# HISTORIC AND DESIGN REVIEW COMMISSION

**HDRC CASE NO:** 2022-577  
**ADDRESS:** 305 LAVACA ST  
**LEGAL DESCRIPTION:** NCB 708 BLK 8 LOT 2 \*\*\*MASTER FILE-COMMON ELEMENTS\*\*\* (305 LAVACA TOWNHOUSES)  
**ZONING:** RM-4, H  
**CITY COUNCIL DIST.:** 1  
**DISTRICT:** Lavaca Historic District  
**APPLICANT:** Tim Rodgers/South Flores Construction  
**OWNER:** Tony Pearson/305 LAVACA TOWNHOUSES  
**TYPE OF WORK:** New construction of two 2-story, single-family structures and one 2-story duplex structure  
**APPLICATION RECEIVED:** March 17, 2023  
**60-DAY REVIEW:** Not applicable due to City Council Emergency Orders  
**CASE MANAGER:** Rachel Rettaliata  
**REQUEST:**

The applicant is requesting conceptual approval to construct two 2-story, single-family structures and one 2-story duplex structure at 305 Lavaca.

UNIT 102

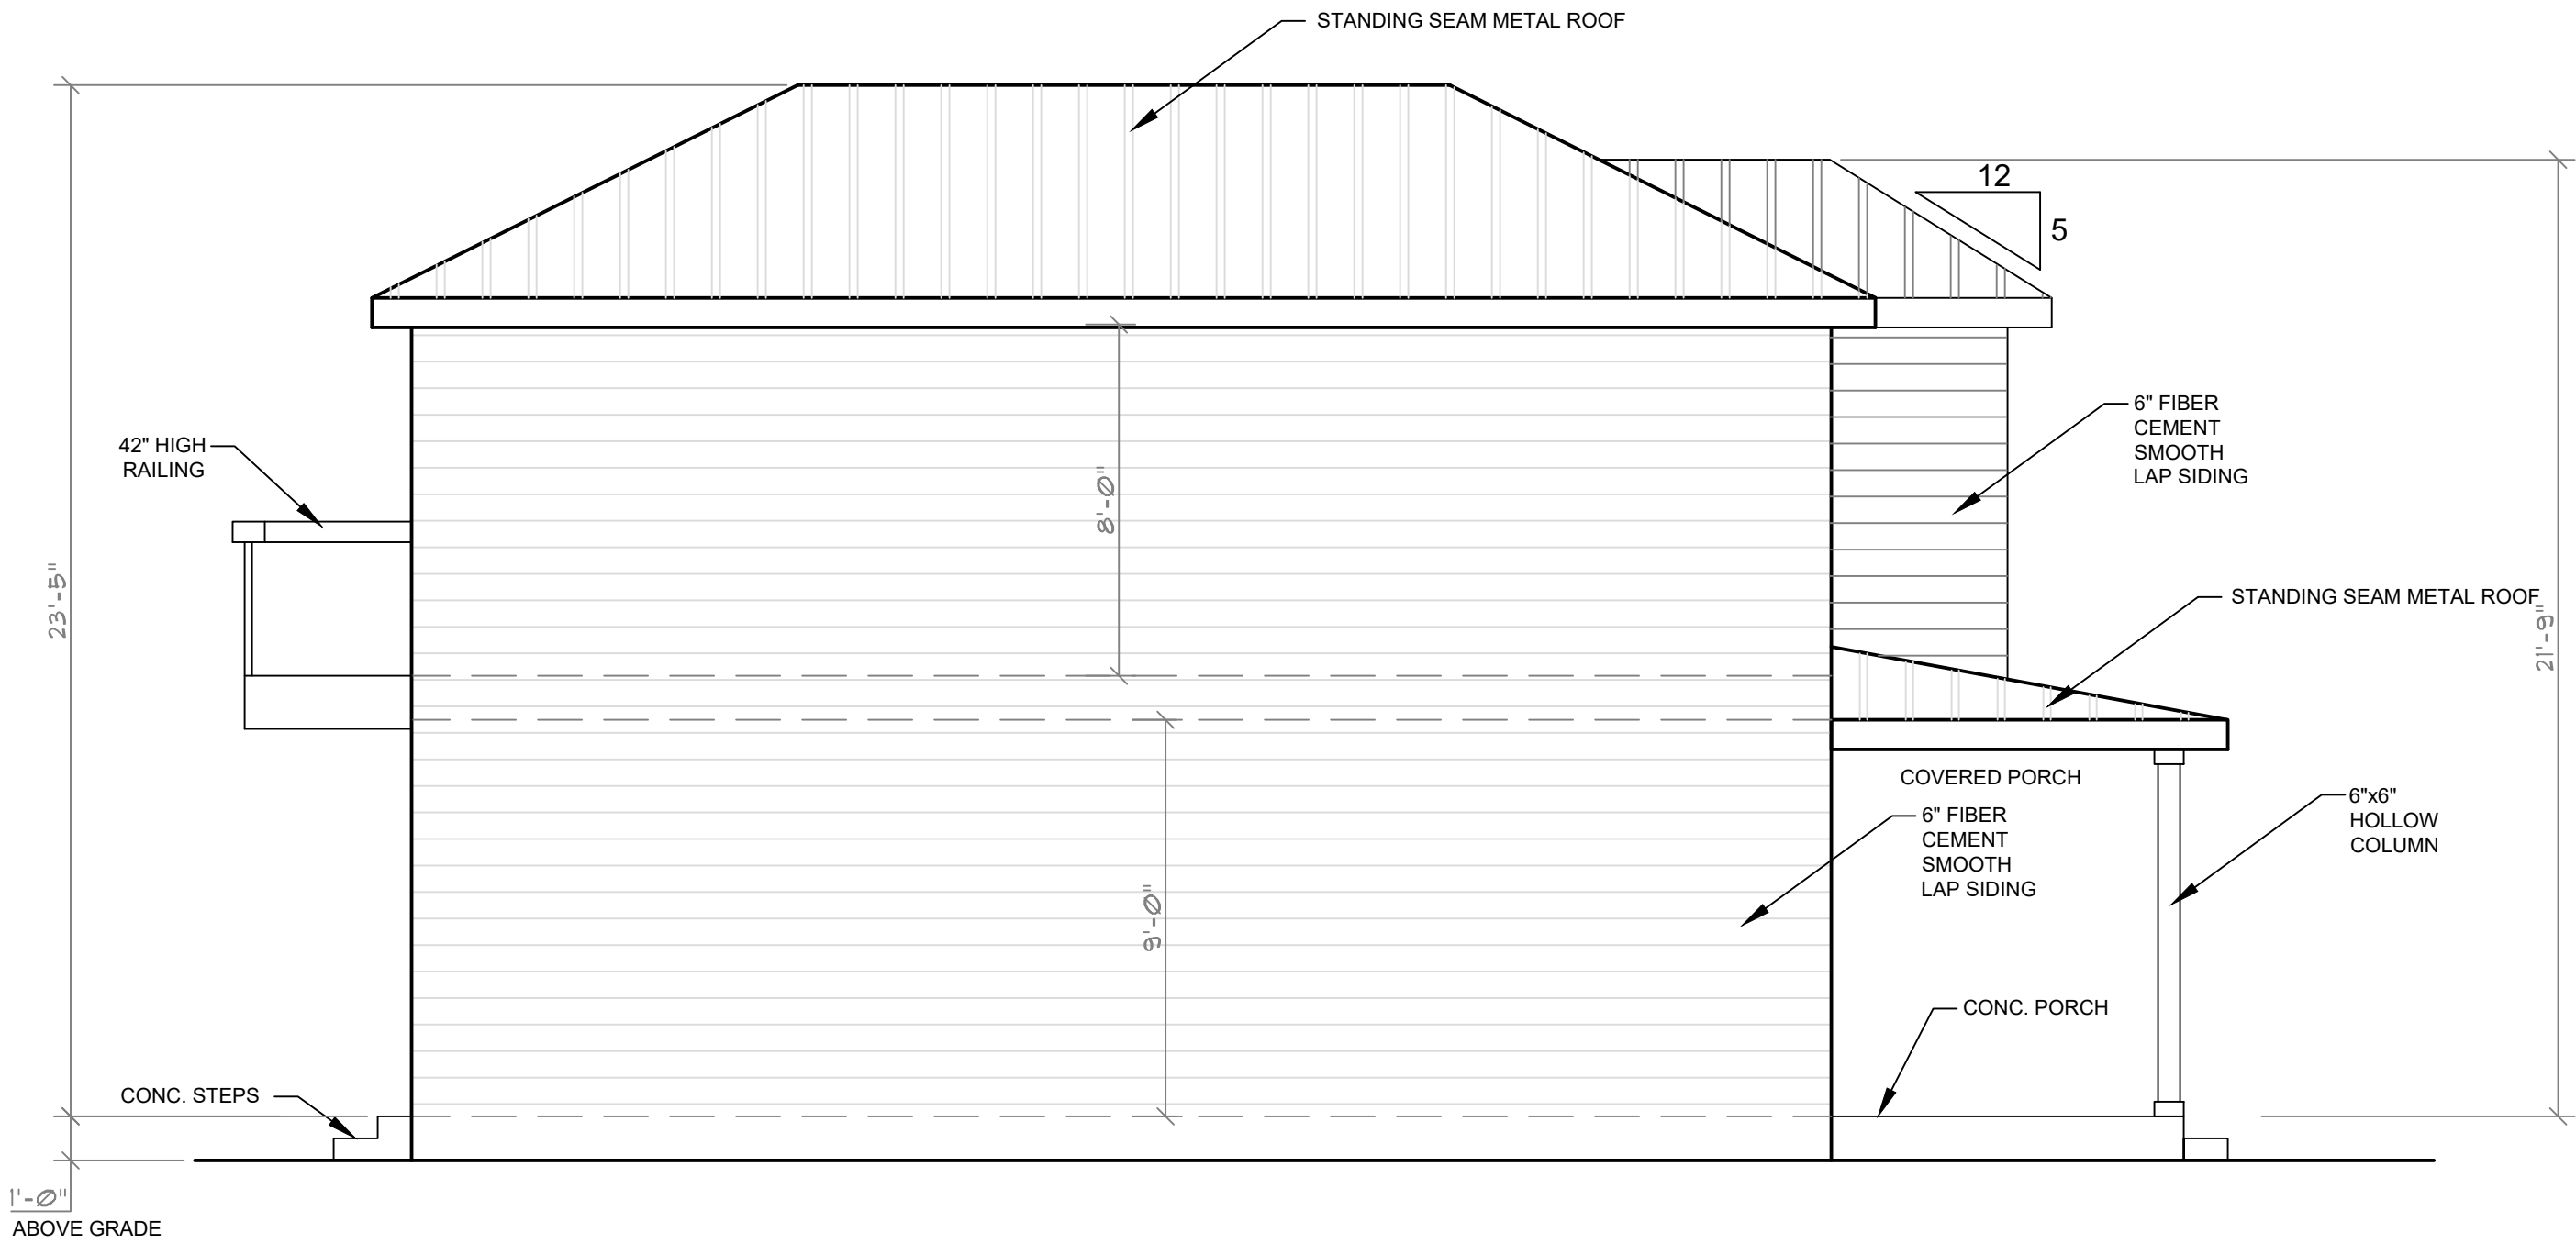
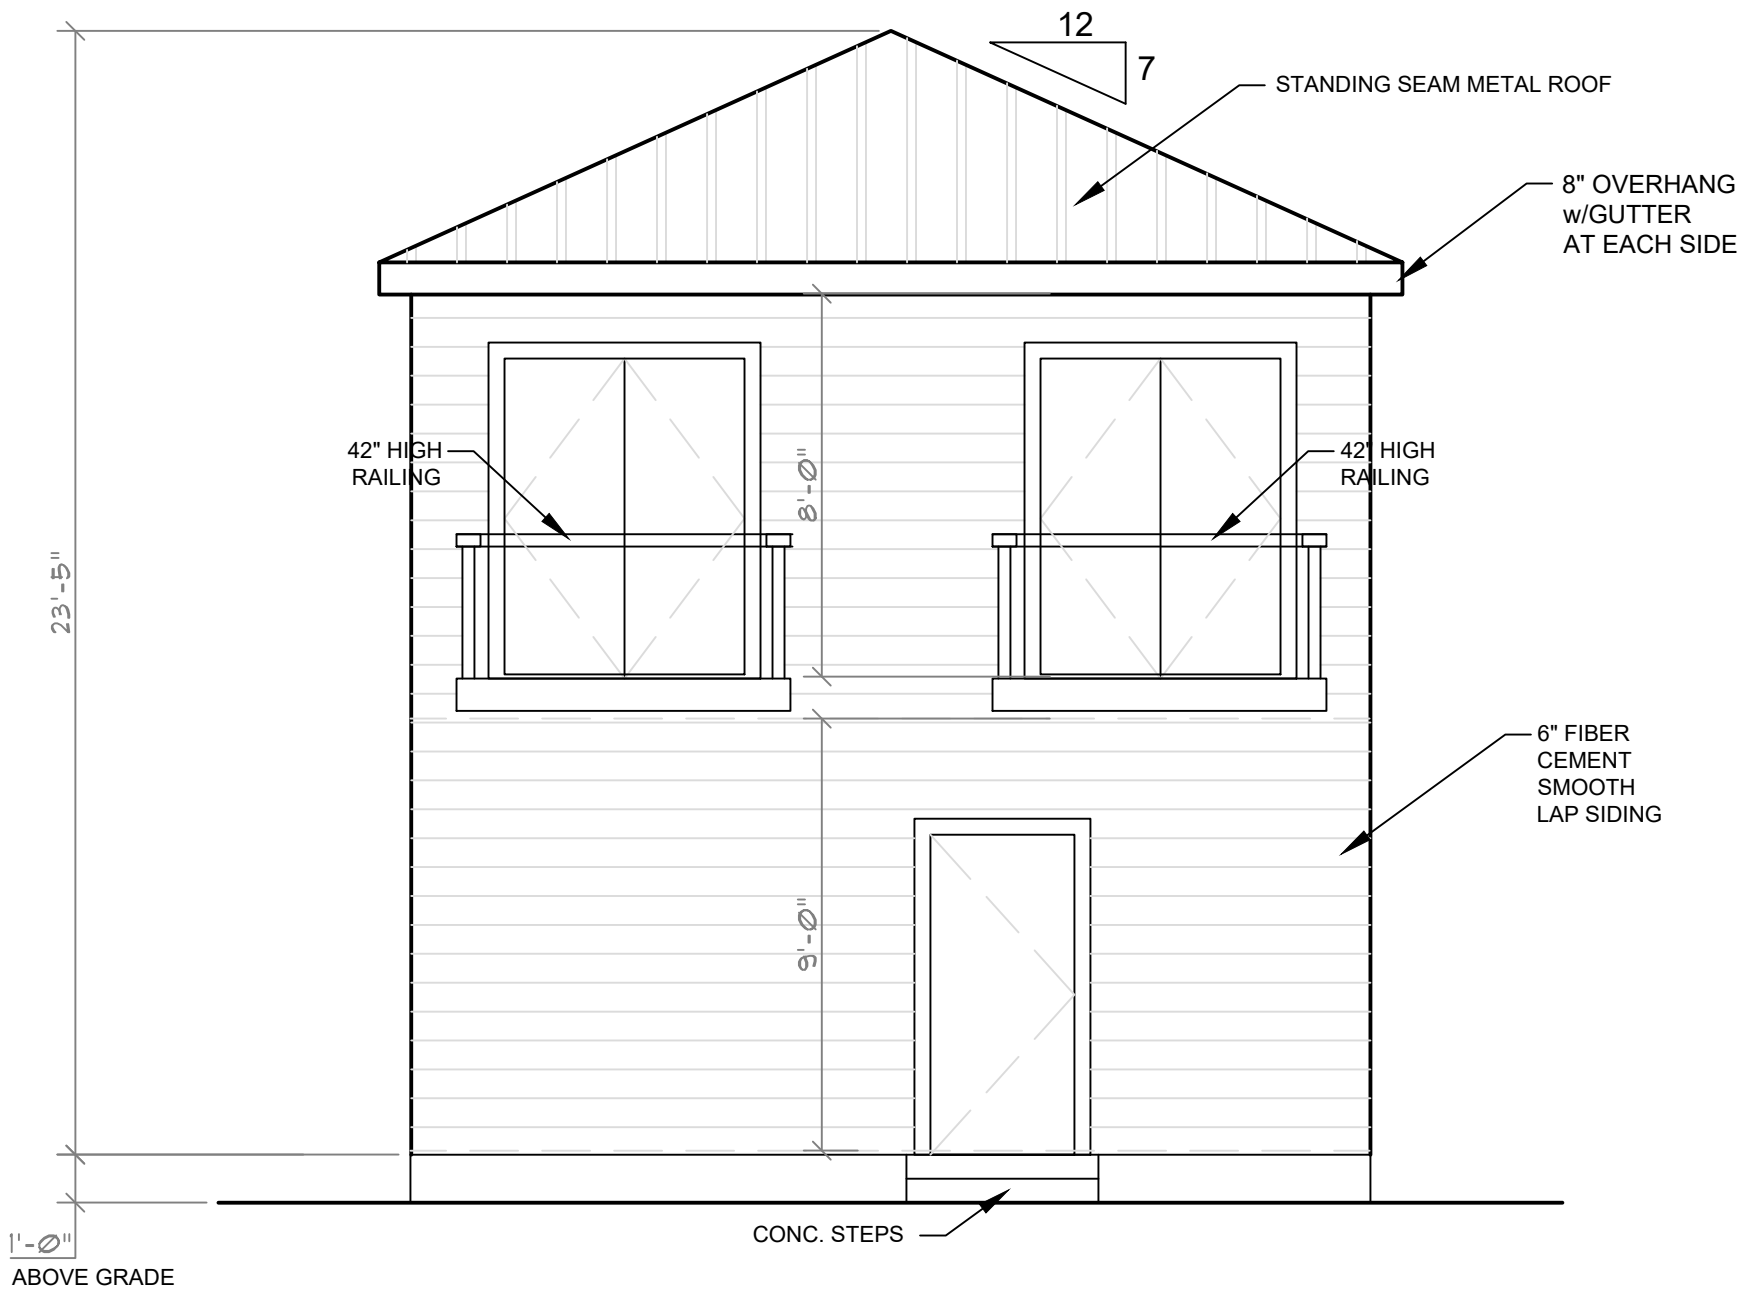
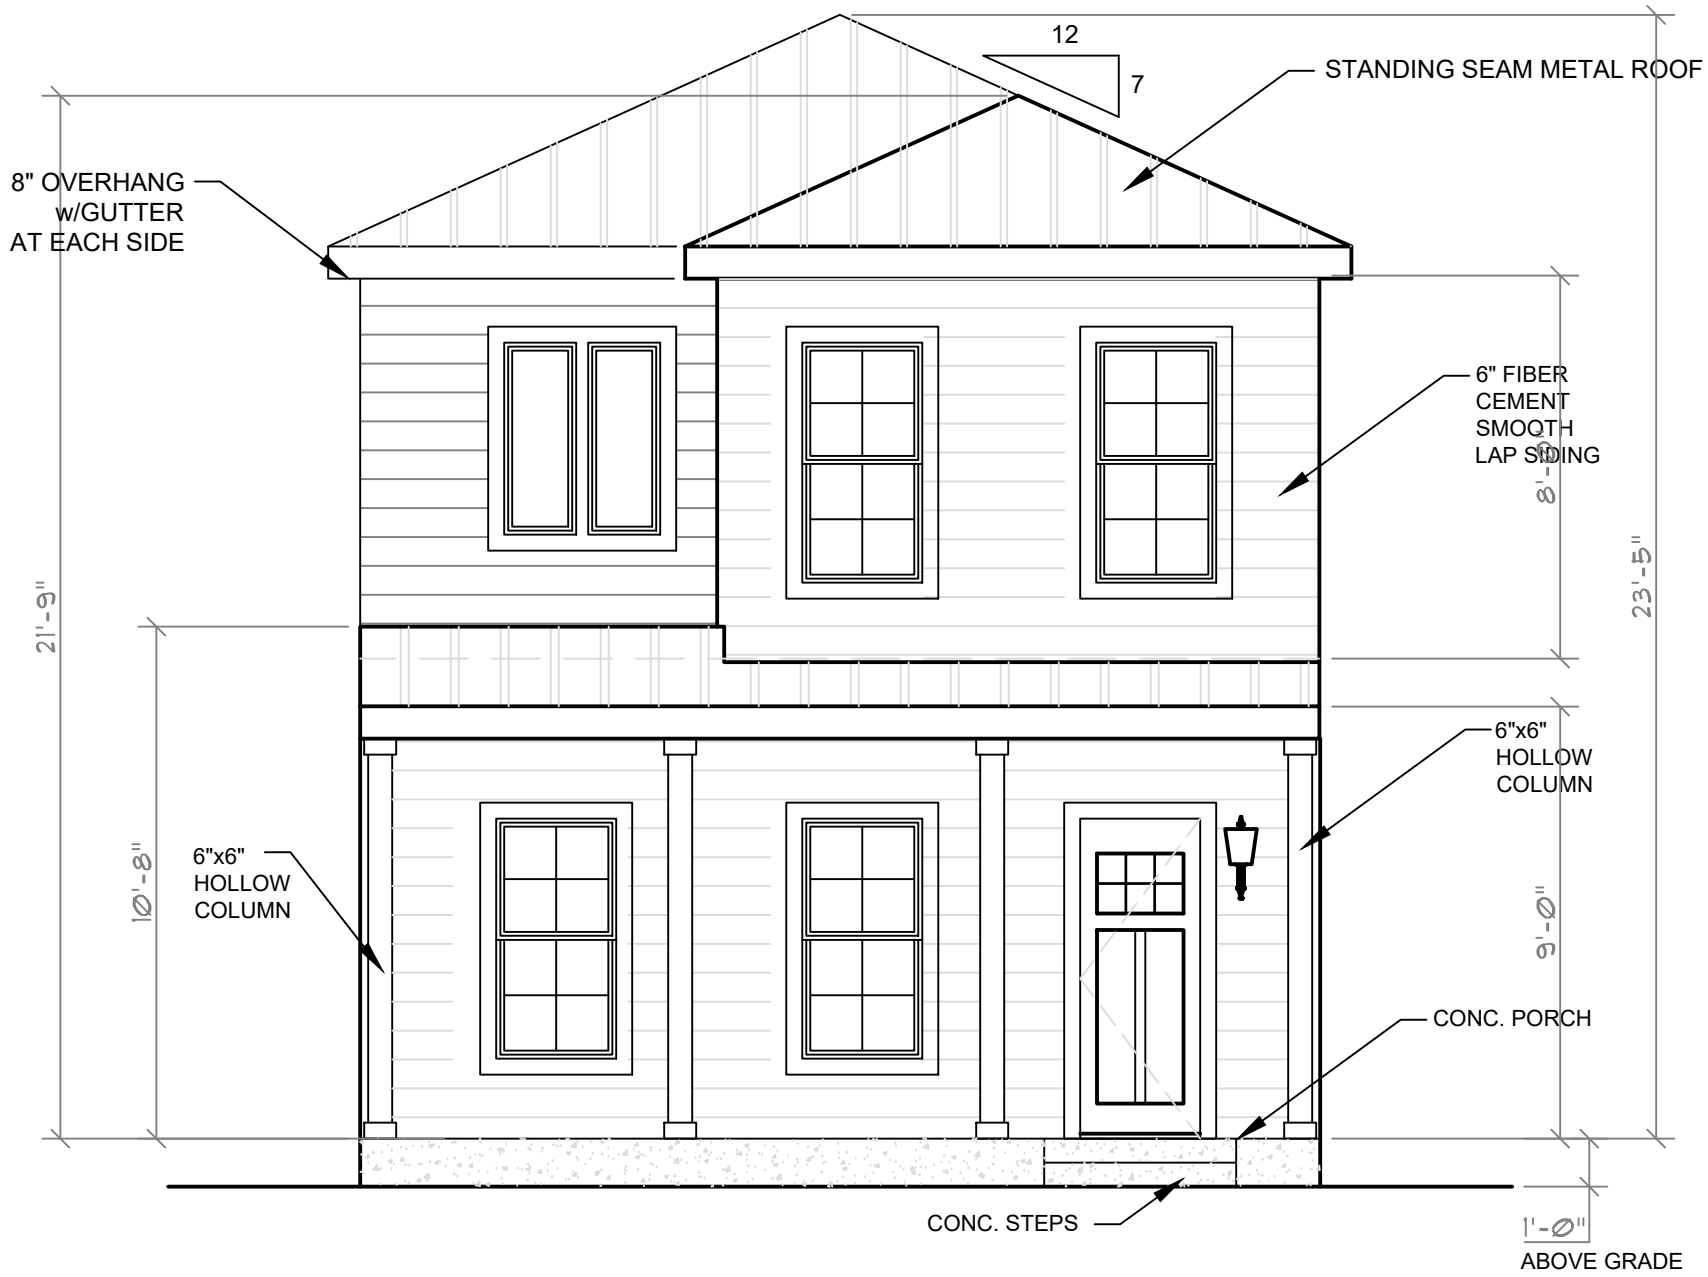
JF: I think the infill development that you provide will help to provide context. On Unit 2, I would recommend looking into more fenestration on the outside facing elevation. Staff can help you with window details regarding true vs faux divided lites etc.
